DE HAVILLAND SERVICE

TECHNICAL NEWS SHEET

SERIES V. No 531  DATE 31.1.55.

VAMPIRE AIRFRAME, GENERAL CIRCULATION.
SUB HEADING 8 GENERAL.

THE DE HAVILLAND AIRCRAFT CO., LTD., HATFIELD, HERTS.	VENOM & VAMP	METHOD OF CORRECT APPLICATION OF HERMETITE WHERE USED ON FUEL SYSTEM COMPONENTS.	R.T. 531/6/53 22/6/53	R12 PT 136
--	-----------------	---	-----------------------------	------------

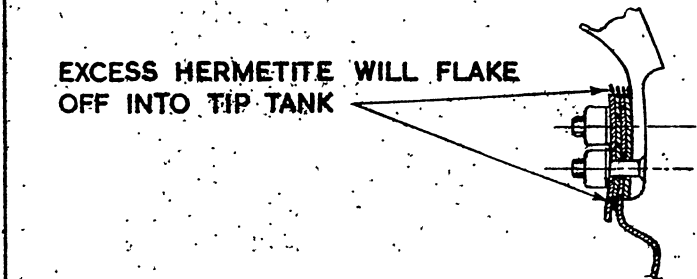
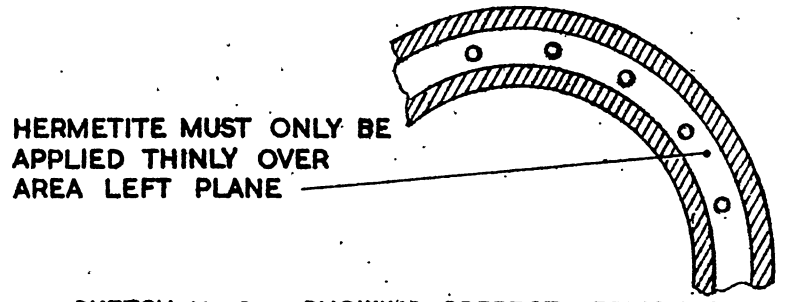
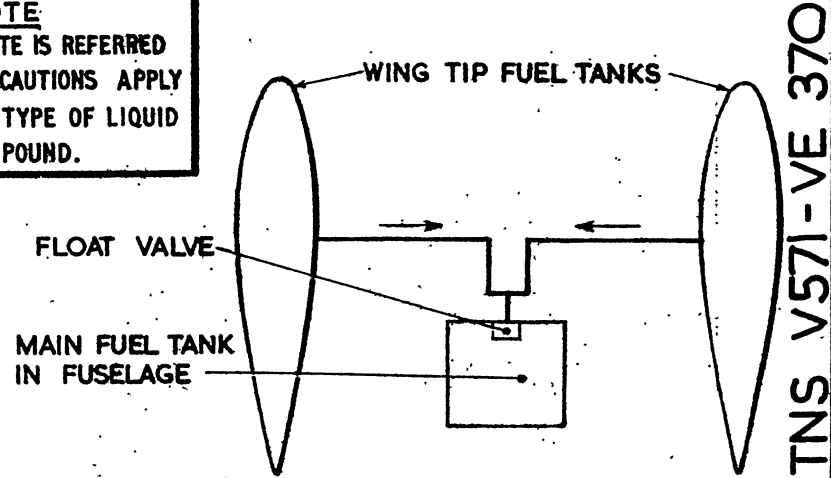
Cases have arisen where flakes of solidified liquid jointing compound have entered aircraft fuel systems, and have interfered with the correct functioning of certain valves.

Drawing R.12 Pt.136 attached shows typical examples of how excess solidified jointing can flake off into fuel tanks. Sketch No.3 of the drawing shows the correct application of the jointing compound to a typical surface.

SKETCH No. 3 SHOWING CORRECT APPLICATION OF HERMETITE TO A TYPICAL SURFACE

NOTE
WHERE HERMETITE IS REFERRED TO THE SAME PRECAUTIONS APPLY TO ANY OTHER TYPE OF LIQUID JOINTING COMPOUND.

HYDRAULIC PIPES: METHOD OF LASHING.
ALL MARKS OF VAMPIRE AIRCRAFT.

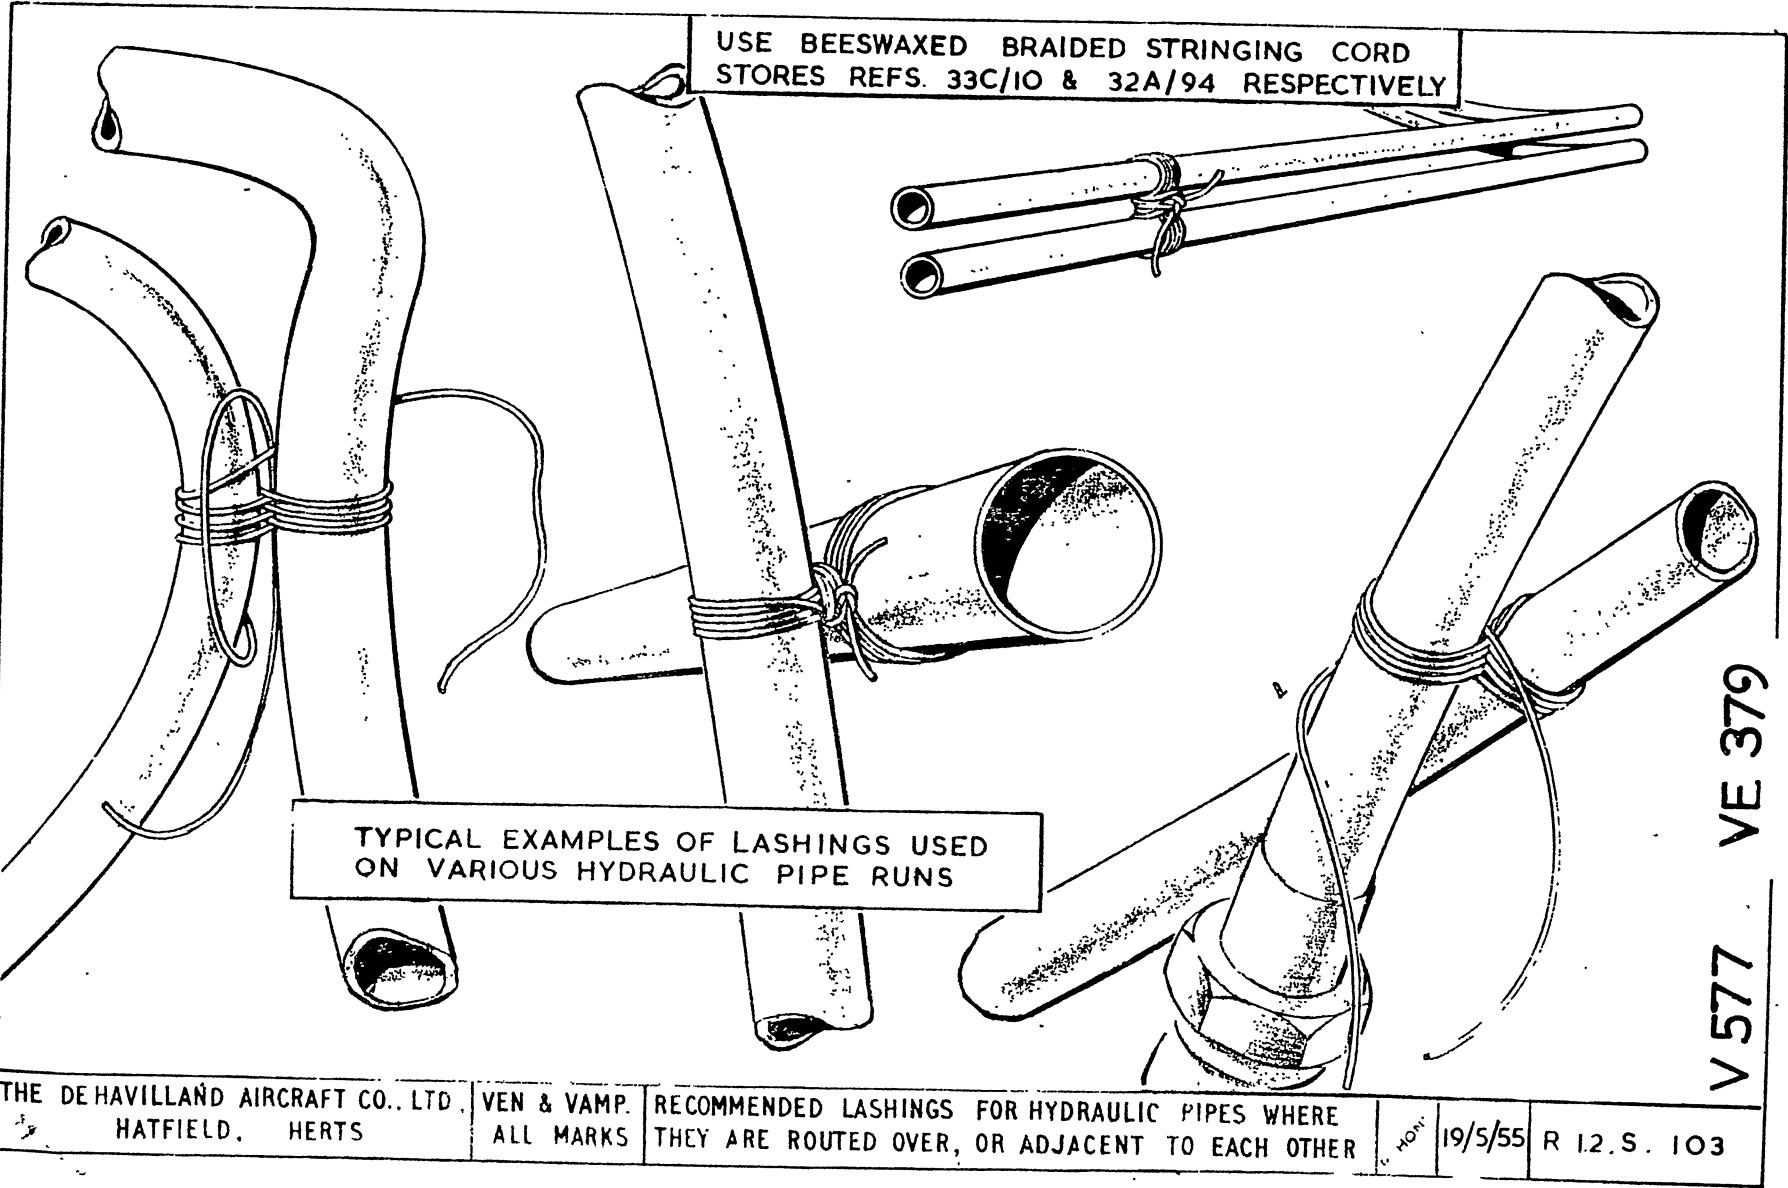
Cases have occurred where Hydraulic Pipes, which are routed across or adjacent to each other, have chafed. The object of this Technical News Sheet is to familiarise personnel with this method now used during manufacture of Vampire Aircraft, to prevent this fault from occurring.

Where chafing as described above is suspected, it is recommended that the pipes be secured together with a figure of eight lashing as shown on the attached Drawing R.12.S.103.

VAMPIRE MARKS N.F.10, T.11, T.55, SEA VAMPIRE MARK T.22.

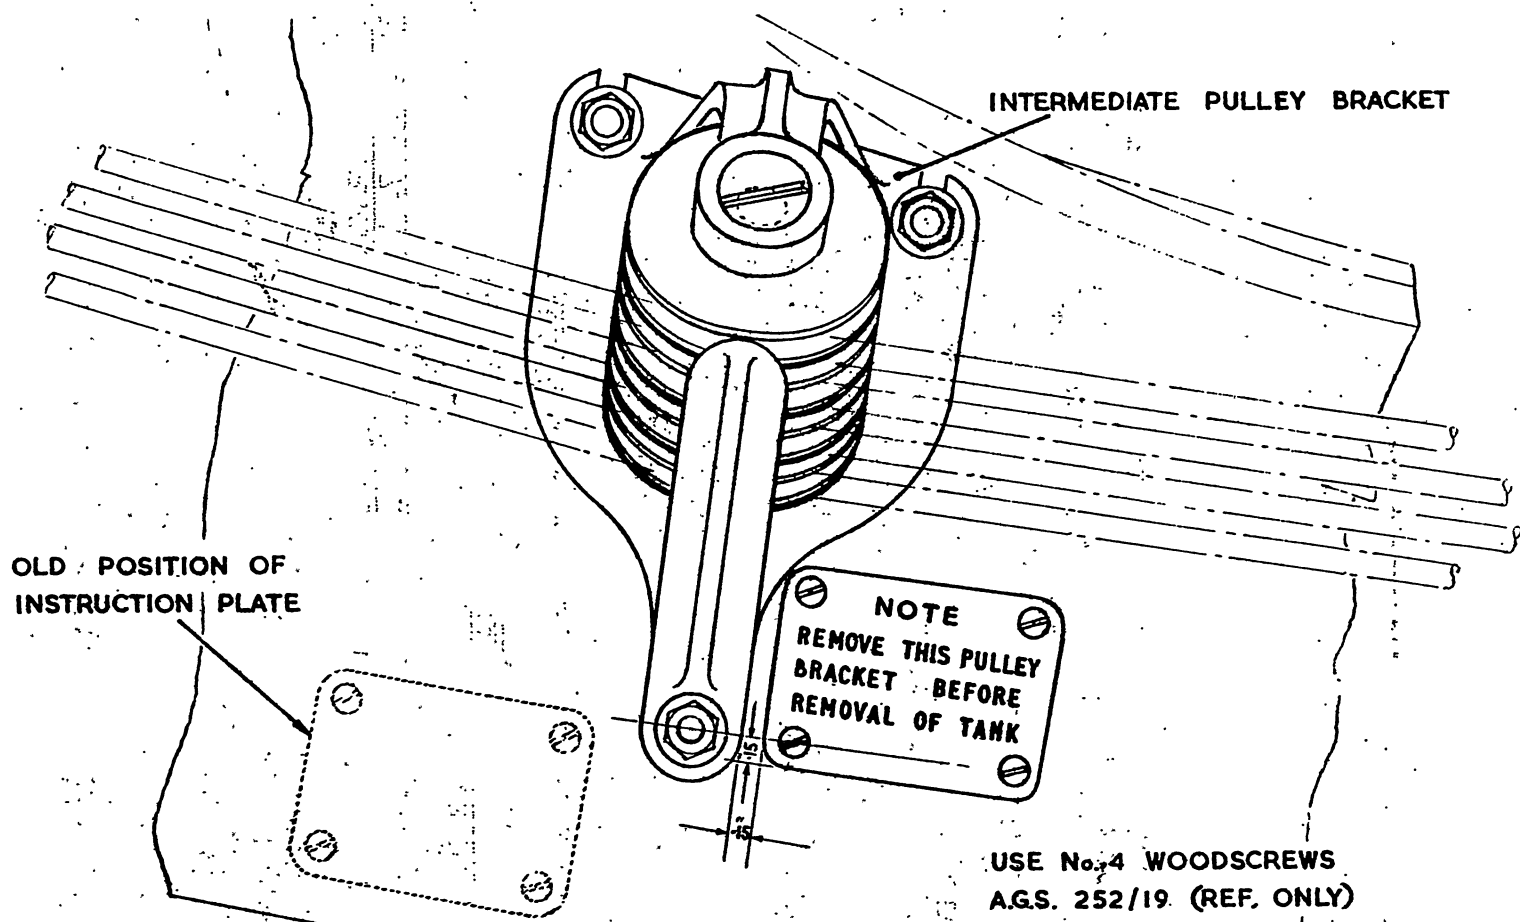
In some cases a warning label adjacent to the pulley bracket is obscured by electrical cables. The object of this Technical News Sheet is to enable the operator to re-position the label where it can be more easily observed.

When next removing the main fuel tank, before the actual withdrawal of the tank from the fuselage remove the flying control pulley bracket reference to above. If the Instruction Plate, "Note, remove this pulley bracket before removal of Tank," is not clearly visible to the operator, then it is recommended that it be re-positioned as per the Drawing R.12.FS.178.

ASSEMBLY N°	SCHEDULE N°	N° OFF
R15 TF 101

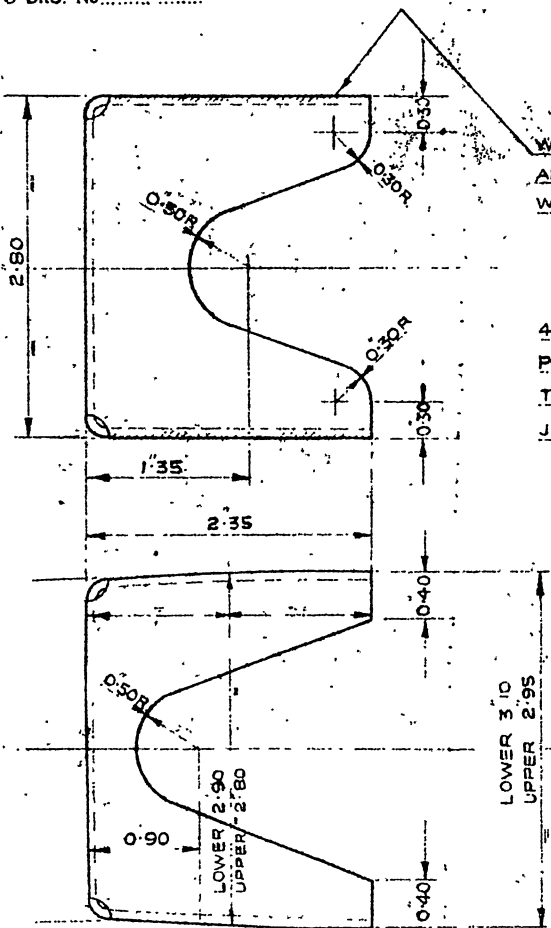
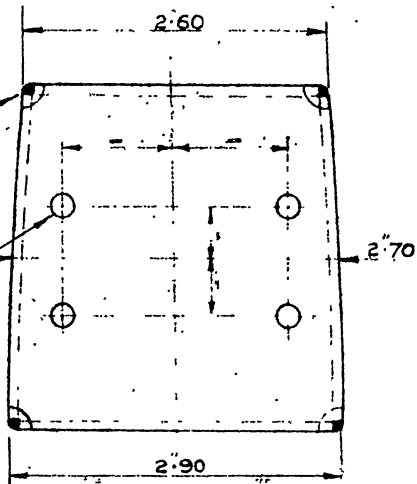
Further to Technical News Sheet V.598, investigations have revealed possibility of cracking of the weld joints on the steel nut plates on Fin number 5 forward of the fin rear spar, which lead to cracking of the fin web in way of the rudder top hinge bracket attachment. This is attributed flying at speeds in excess of the recommended Mach number limitations.

WELD EDGES TOGETHER
AND FILL CORNER HOLES
WITH WELD.

NORMALIZE AFTER WELDING

DRAWING No. 12 Y 501. SHEET 64
ISSUE 2

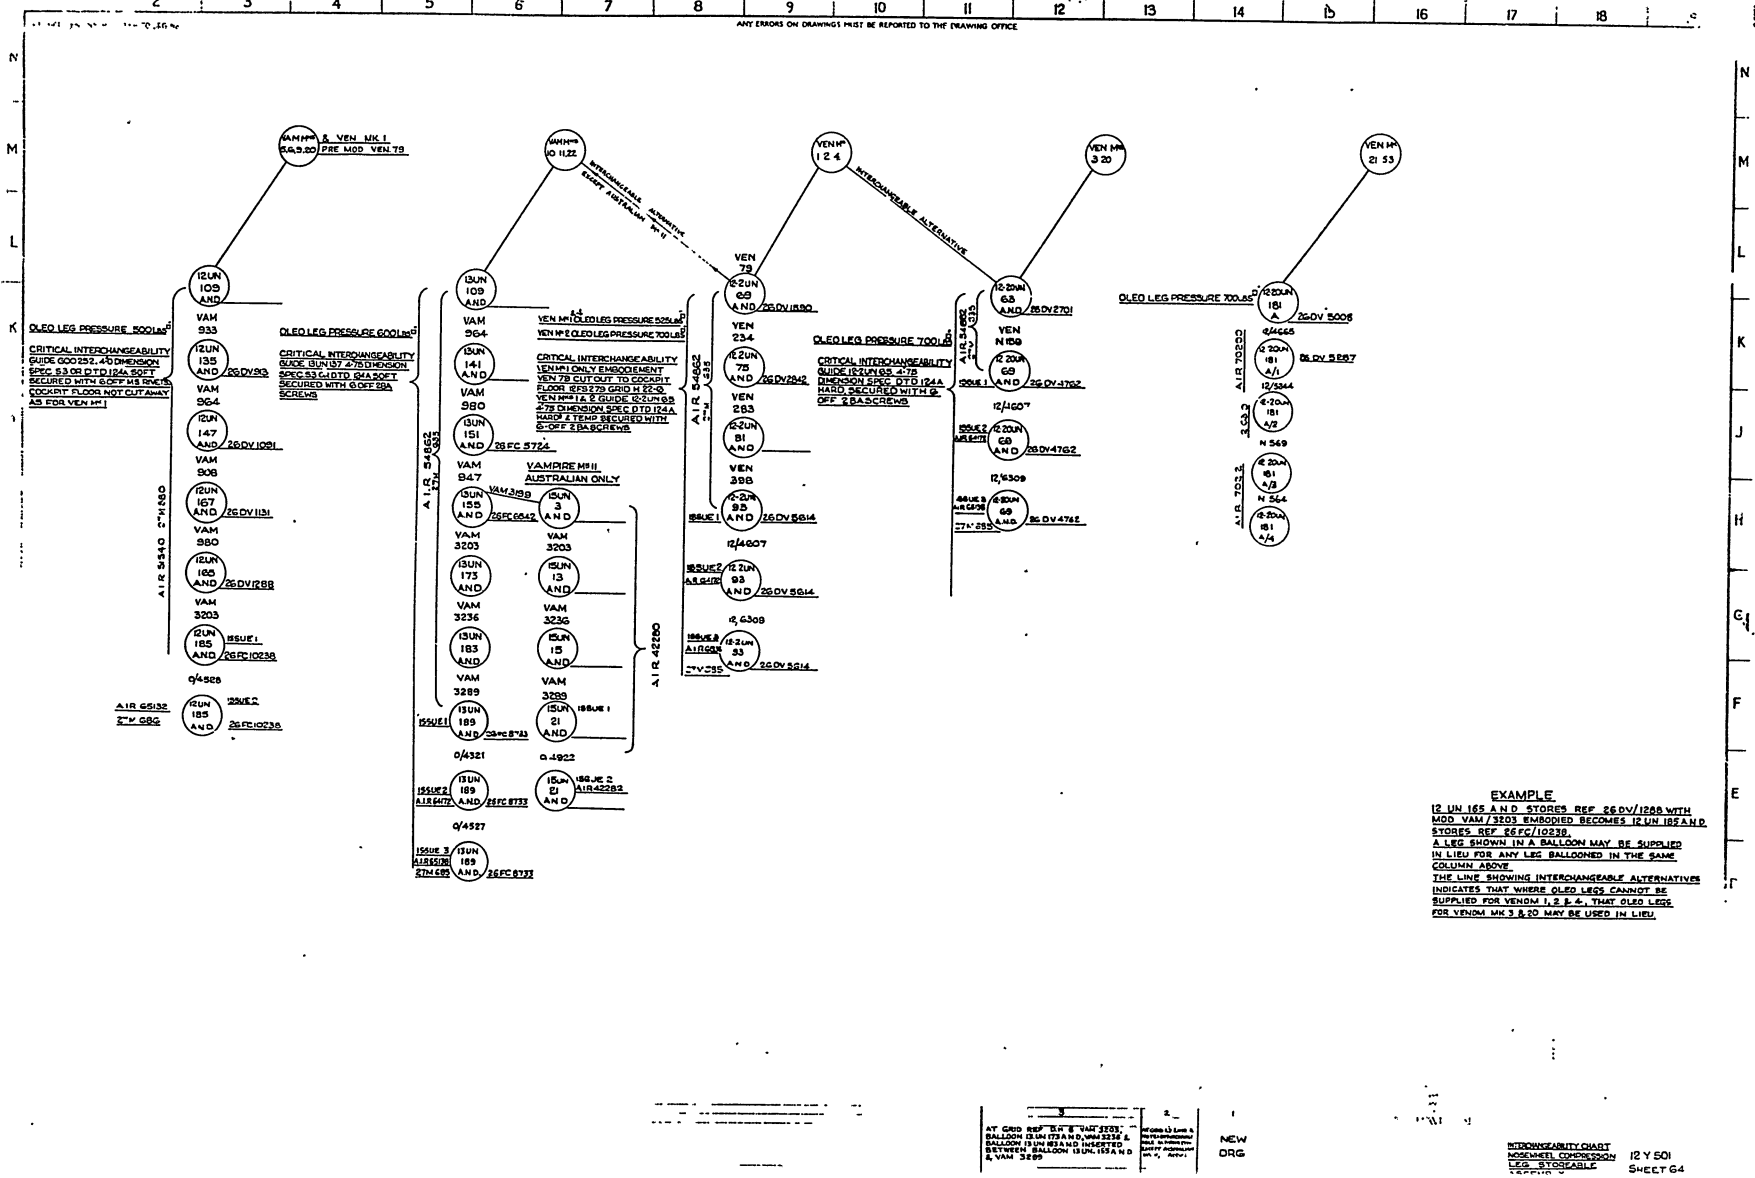
This Technical News Sheet has been issued with the drawing 12-Y-501, sheet 64, issue 3, to bring the operators' attention to the fact that some nose undercarriage assemblies fitted to Vampire and Venom aircraft are interchangeable.

Issue 3 of the drawing differs from issue 2 by the addition of ballons 13.UN.173A/ND and 13.UN.183A/ND, and their respective modification numbers, 3203 and 3236, in the second column from the left.

DETAIL 'A'
CORRECT ASSEMBLY.

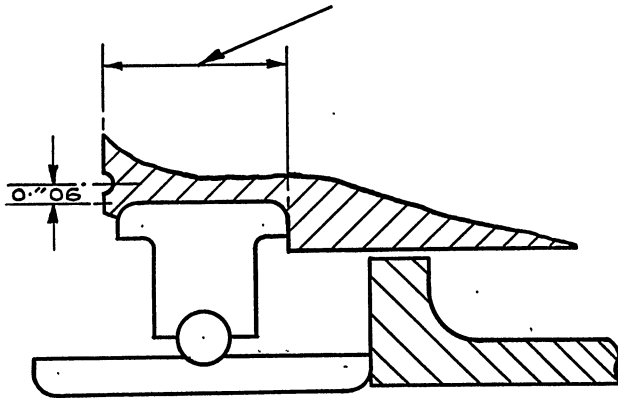
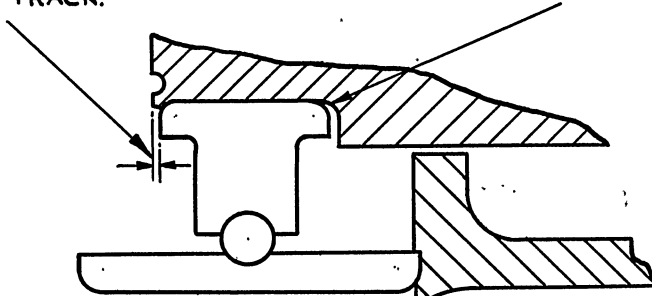
The attached drawings serve to indicate and clarify the foregoing. ~~short note is also given on the correct method of assembly.~~

- 1) A 1/32" RADIUS SPHERICAL ENDED PUNCH SHOULD BE USED.
- 2) DEPTH OF CAULKING TO BE APPROX .03
- 3) CENTRE OF CAULKING TO BE APPROX .06 FROM EDGE OF HOUSING.
- 4) NUMBER OF CAULKS TO BE THE SAME AS BEFORE - SPACED ONE THIRD OF THE DISTANCE BETWEEN THE OLD CAULKS. THIS ALLOWS FOR A FURTHER RACE CHANGE WHEN NECESSARY.

HOUSING DEPTH TO BE :-
 WIDTH OF RACE OUTER TRACK PLUS 0.030 + $.010$
 - $.000$

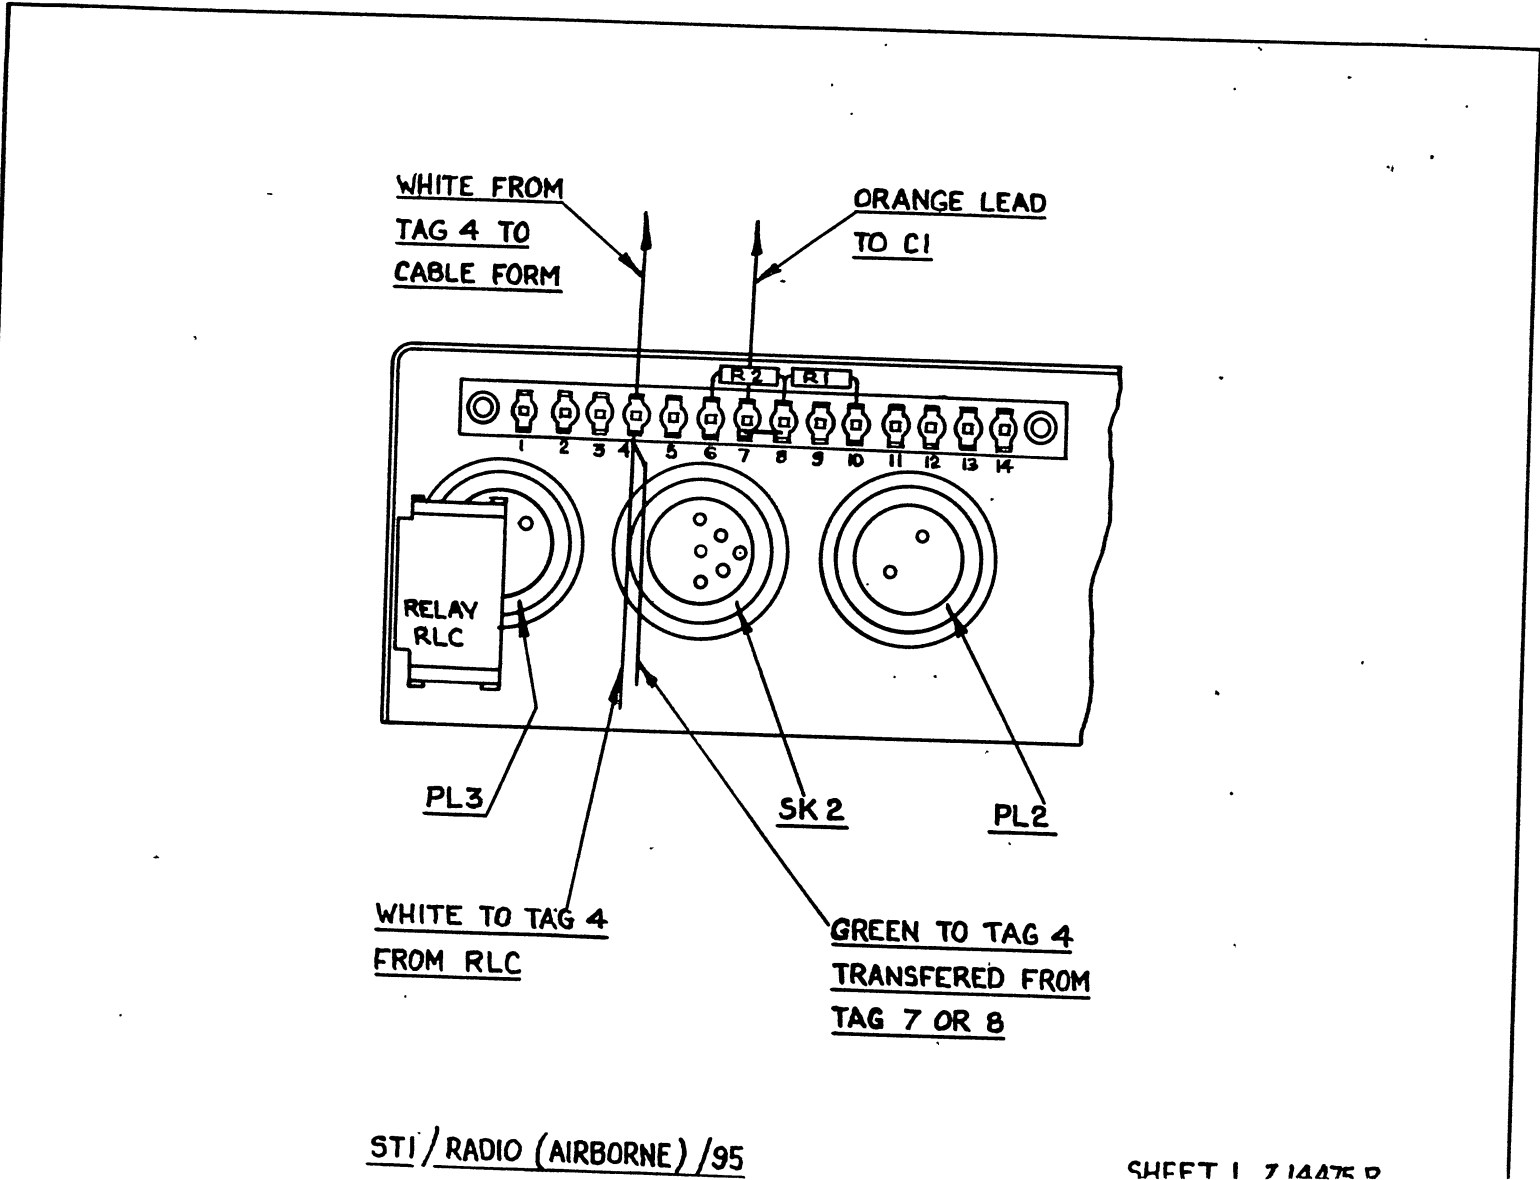
Within twentyeight days of receipt of this Instruction the following procedure is recommended:-

- (a) Check whether the Green wire from Relay 'RLC' is connected to tag 7 or 8 (see Drawing Z.14475R, Sheet attached).
- (b) Should this be found, the green wire is to be removed from this tag and connected to tag 4 (see drawing).
